BLOCK 136

LAND USE HEARING #2

JANUARY 22, 2015

Plan - Revised

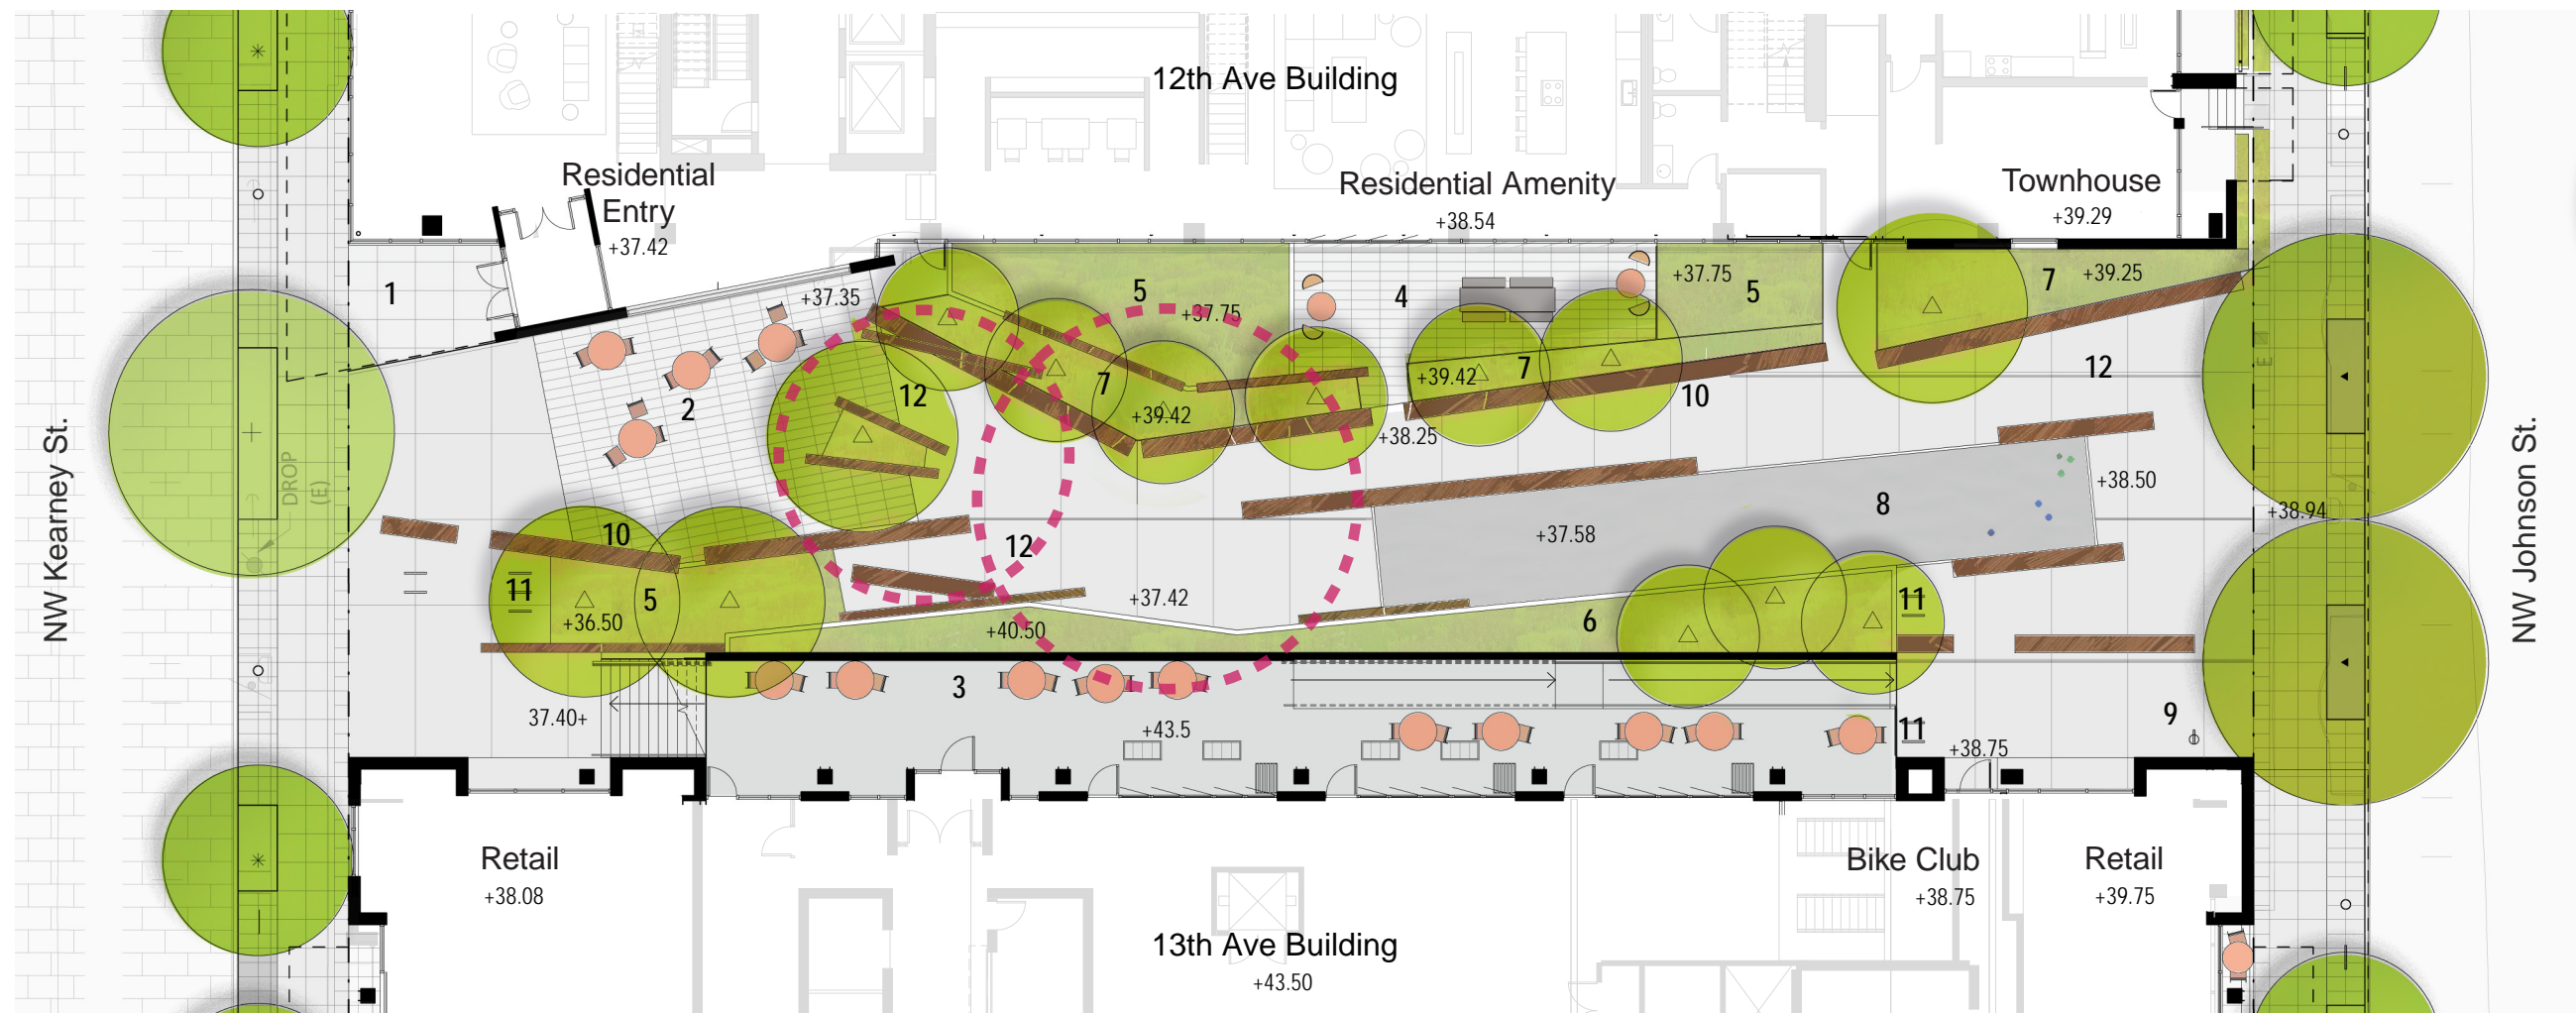
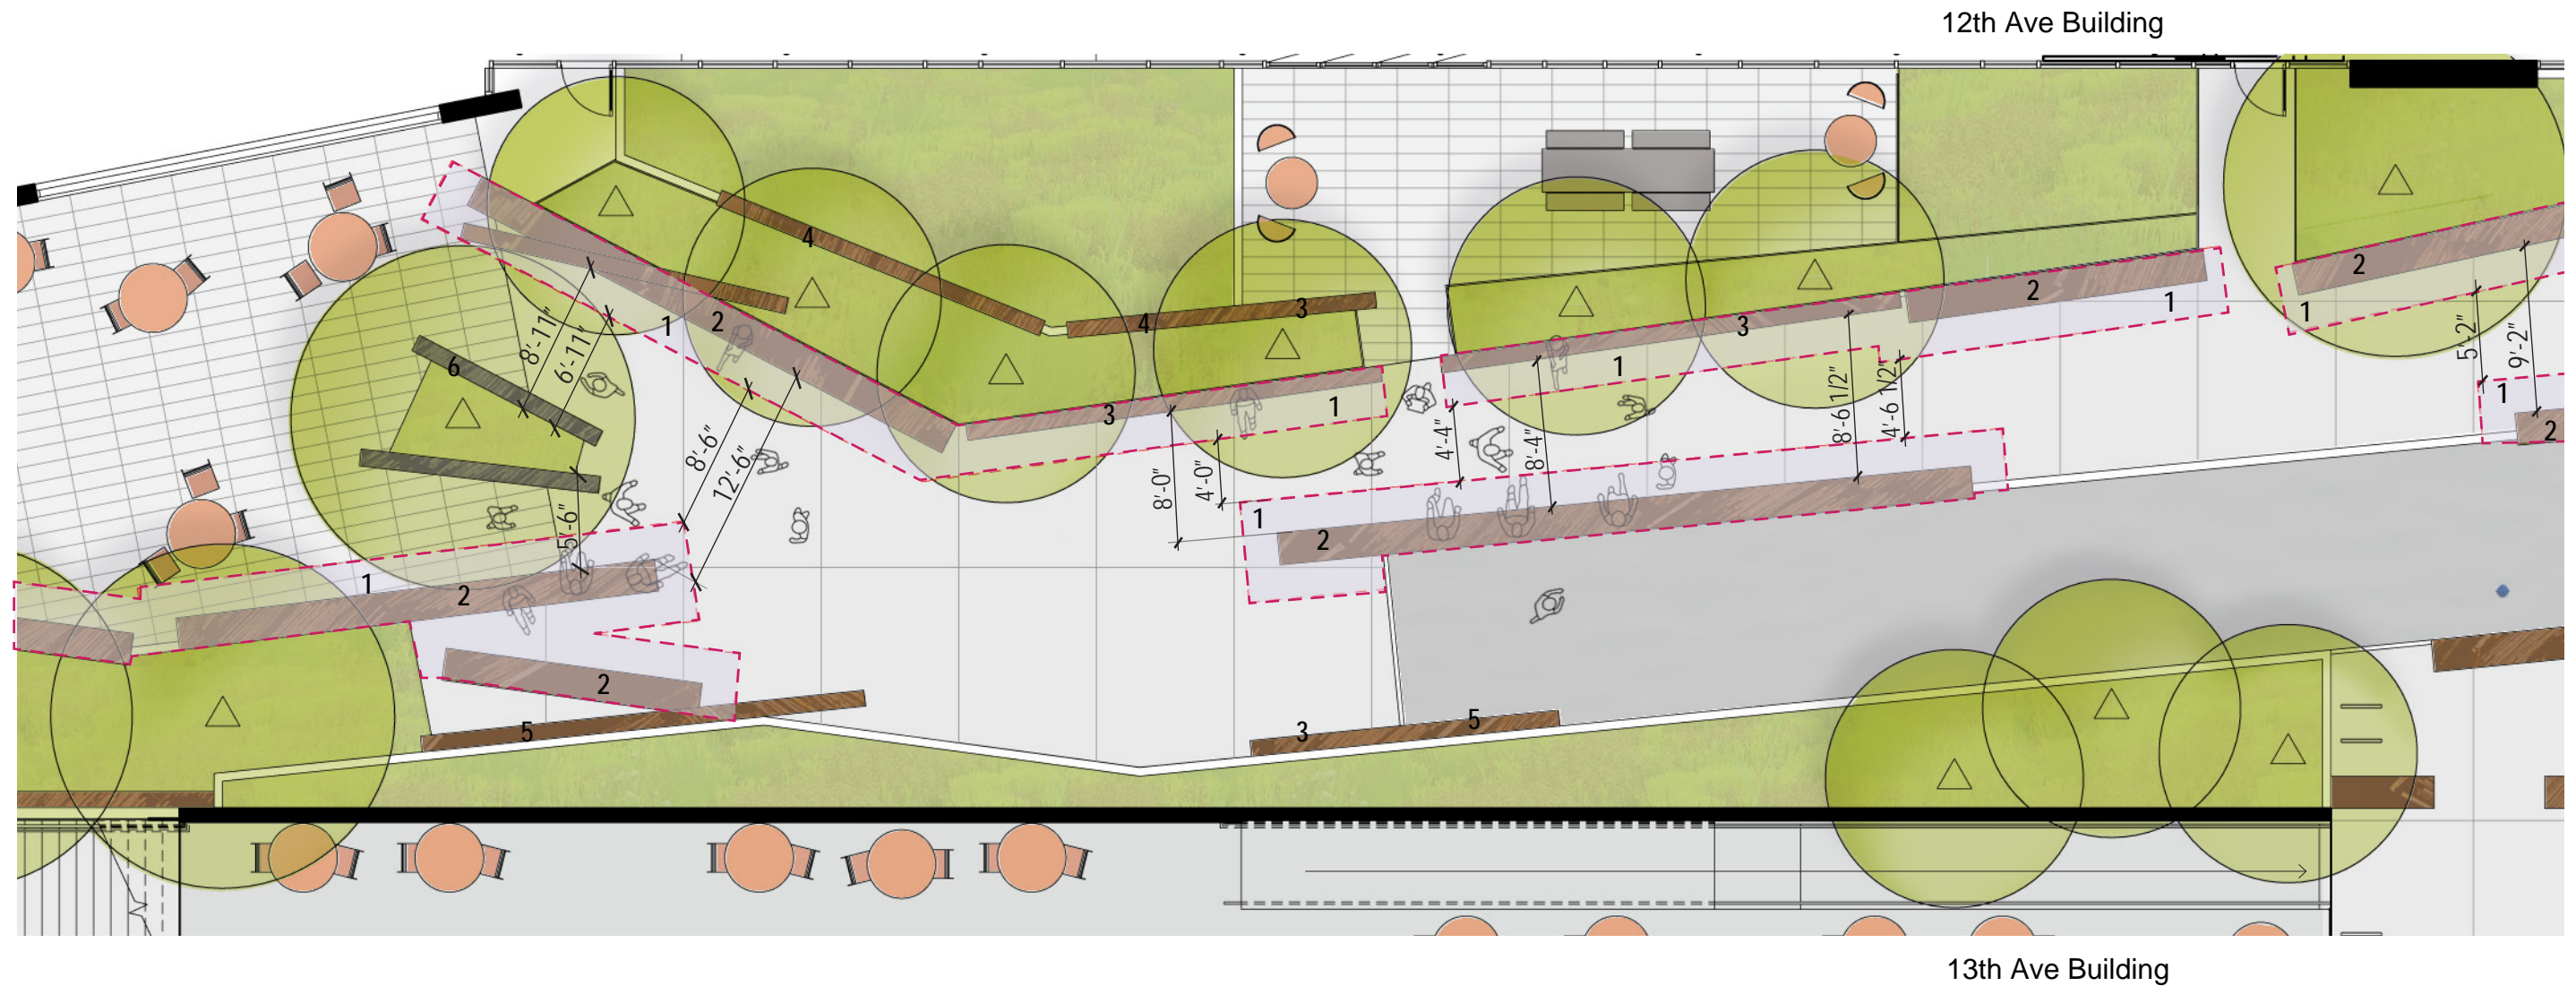
- Study the pinch point
- Detail the flush log so that it isn't slippery
- Detail the connections of the log benches

10 Log Jam Benches

Reclaimed timber features, range from flush to high. Primarily serve as benches. Details on page 46.
